TECHNICAL BULLETIN  
 UPS5513-4bNAS1  
 15 NOV 2013

**SECTION: 417-02**

Update Prior to Sale: Door Interior Release Handle Lamp Operation

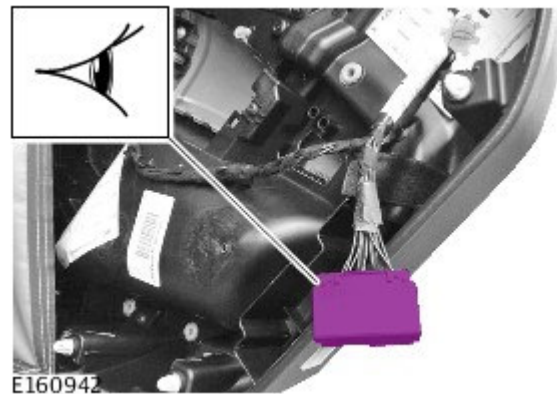
4. Modify only the harness shown in steps 5-8 that comes from the door casing harness, **not** the body harness.

- If required, remove the front right door trim panel for access only (see TOPIX Workshop Manual, Section 501-05).
- Disconnect electrical connector (C3B-C2).

- Locate wires in pins 15 and 17; cut each wire 50mm back from the connector. Strip wires 15 and 17 on the connector side and twist the exposed copper together. Place the splice into the splicing tool, put the wires into the splice, and then crimp all together.

- Strip wires 15 and 17 on the door trim harness side and twist the exposed copper together. Place the wires into the splice which has already been crimped on the other side. Crimp the door trim harness side.

- Wrap the splice in two turns of fleece tape to secure.
- Connect electrical connector (C3B-C2).
- Turn side lights 'ON' and check that the white LED is now working.
